construction bid document addendum 01 - page 01

Project: Southern Maine Community College - Horticulture Greenhouse

South Portland Campus, Maine BGS # 3674

pages: 02 plus attachments date: 11 August 2025

SITE LAYOUT AND UTILITY PLAN

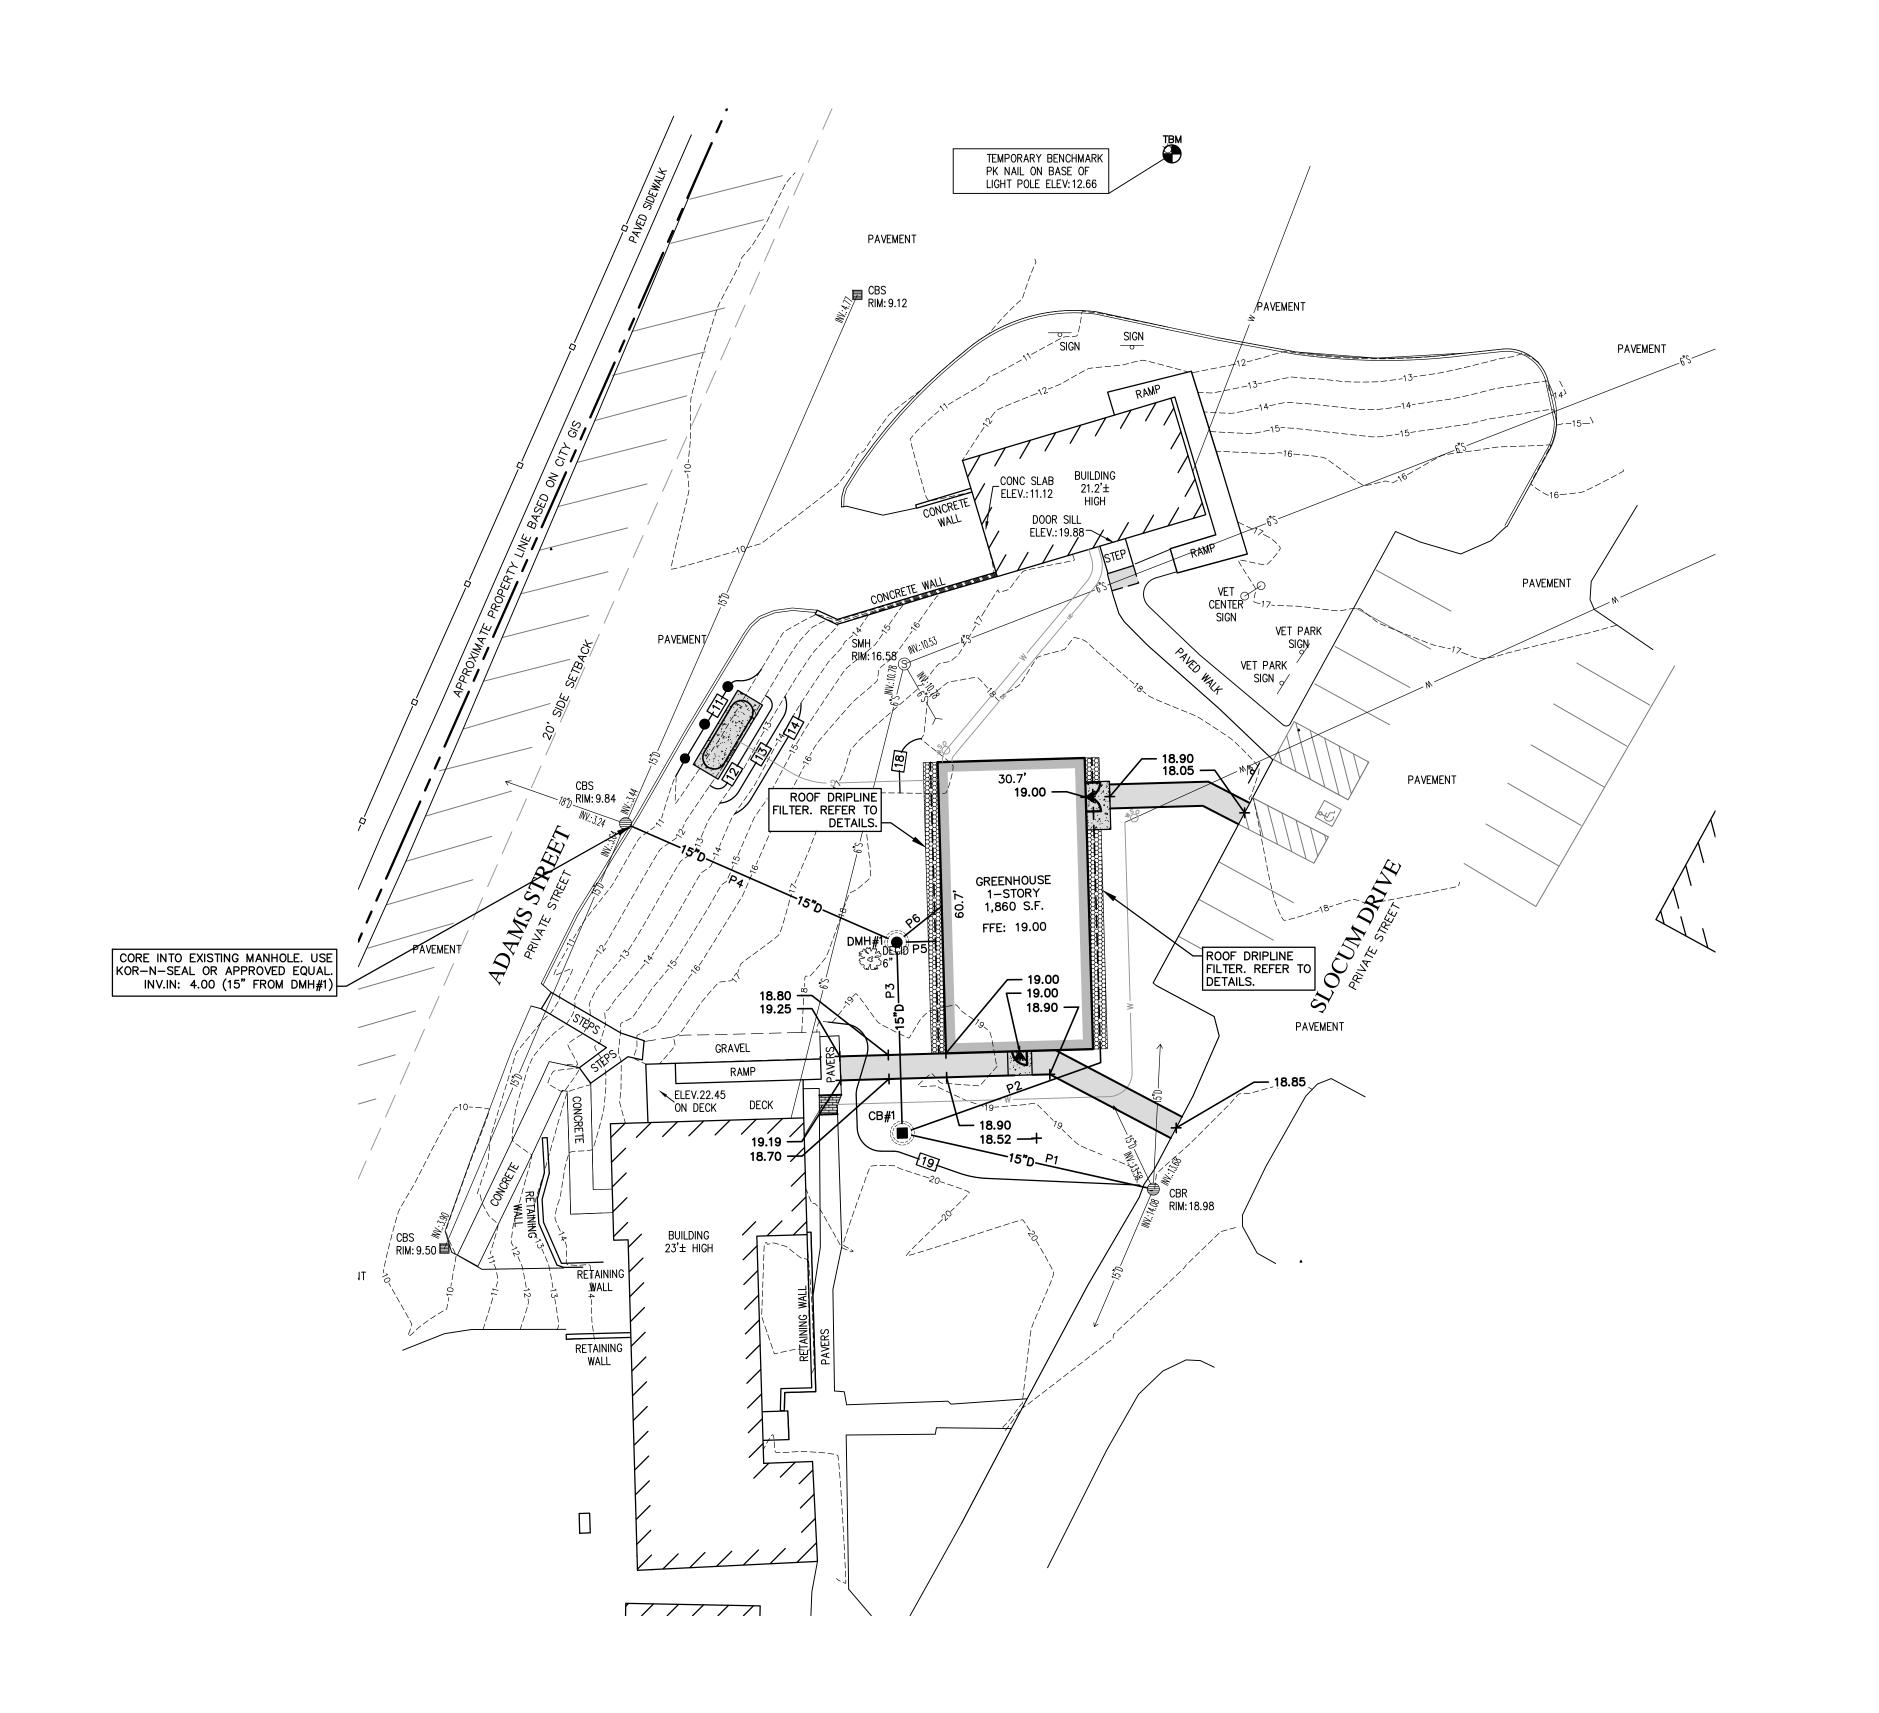
PLANS & DETAILS - Underground water and electrical supply pipe, conduit and wire location shown diagrammatically. Contractor to verify precise underground location in the relative vicinity of the Bay Building south entrance. Contractor to carefully remove and replace existing entry wood steps and landing to allow for trenching. Existing asphalt walkway to be protected during construction and repaired if damaged.

ELECTRICAL SITE PLAN

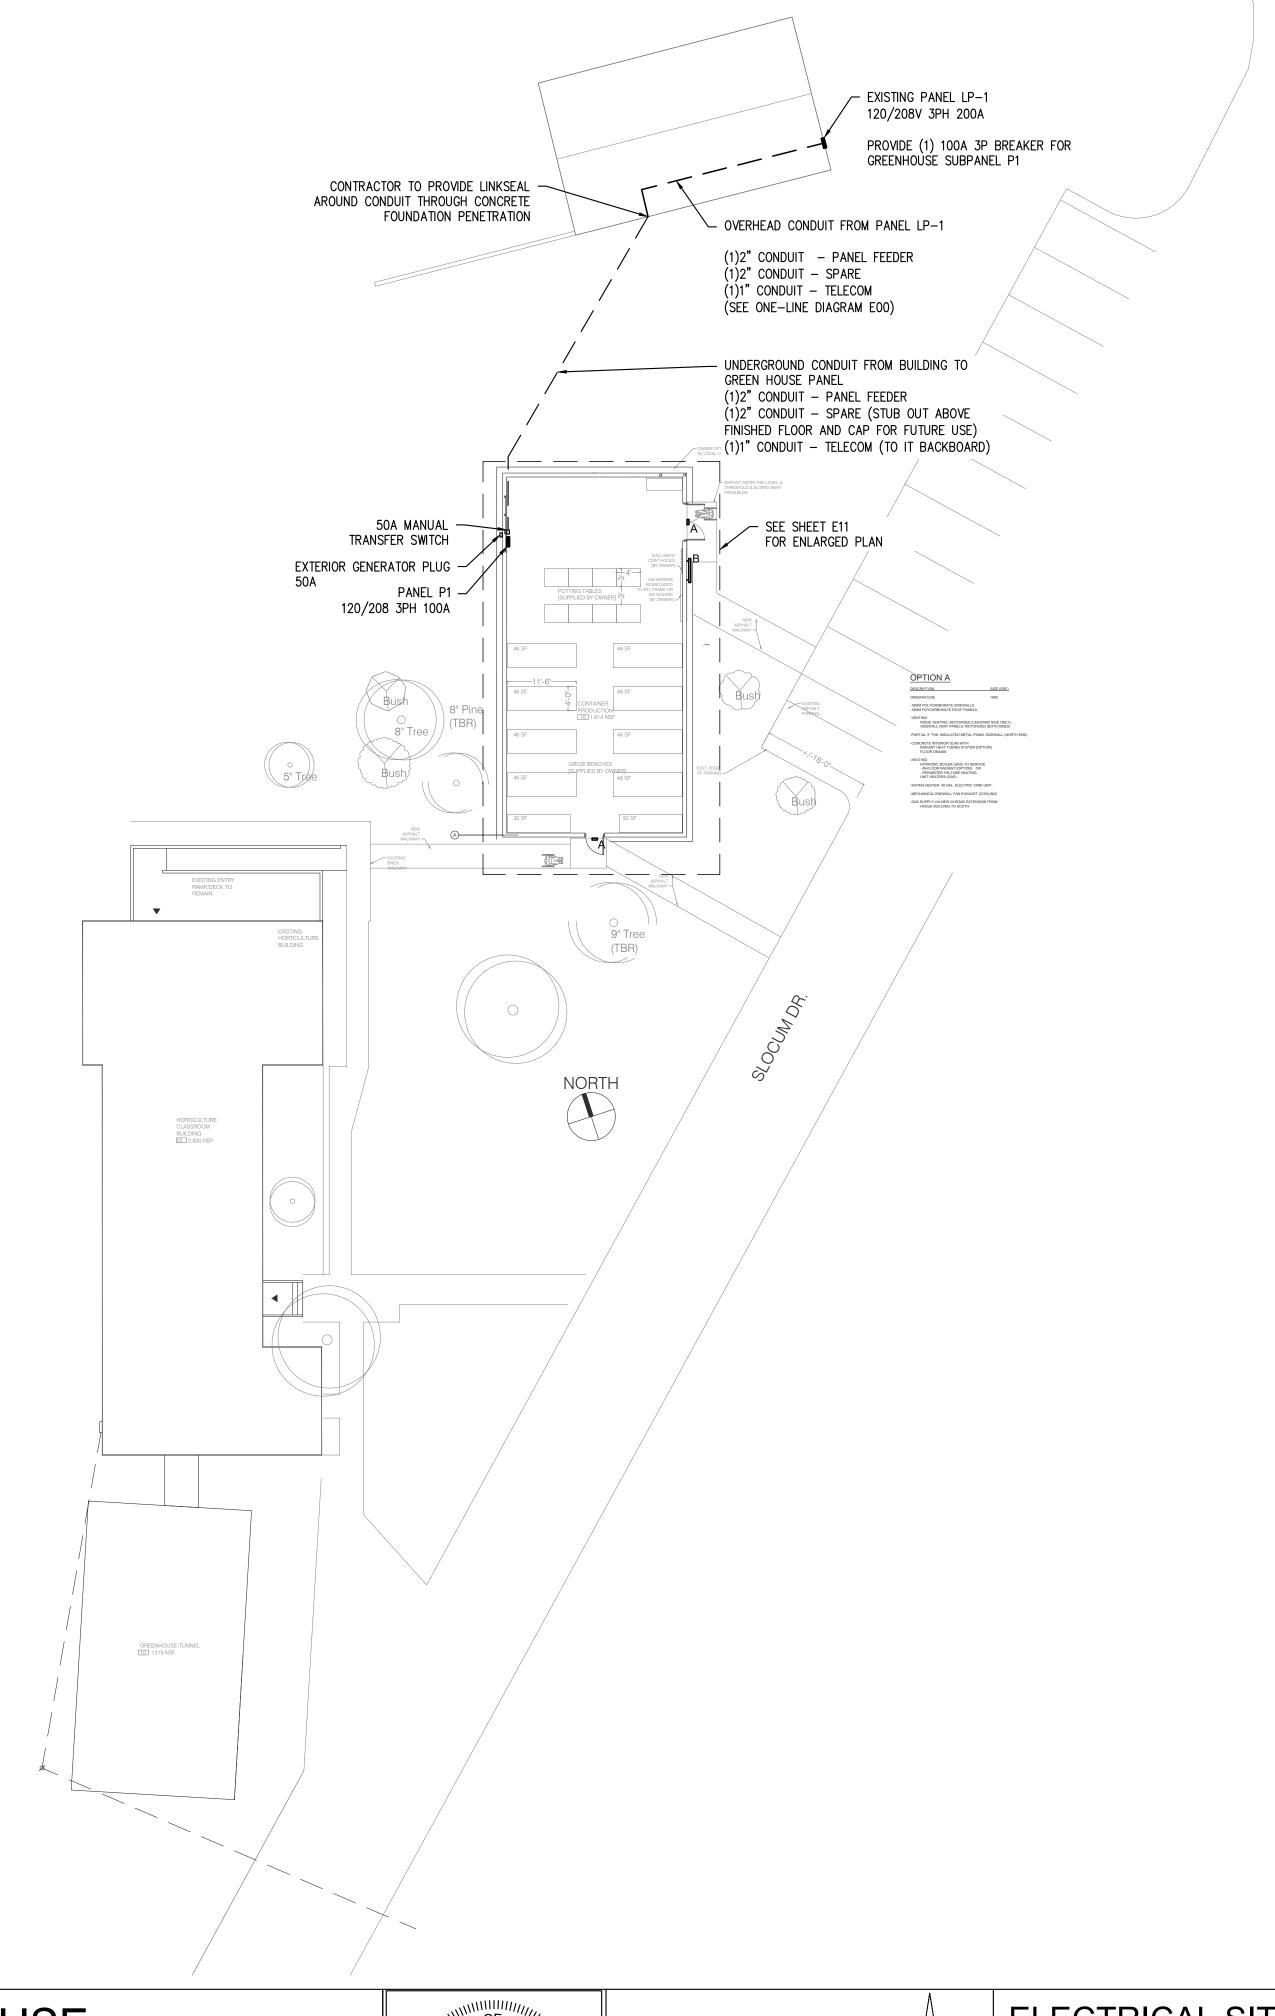
E12 ELECTRICAL SITE PLAN: Underground electrical conduit shown diagrammatically. Contractor to install conduit in ceiling from electrical panel in the Bay Building through the foundation wall to the outside. Cored hole to be sealed watertight.
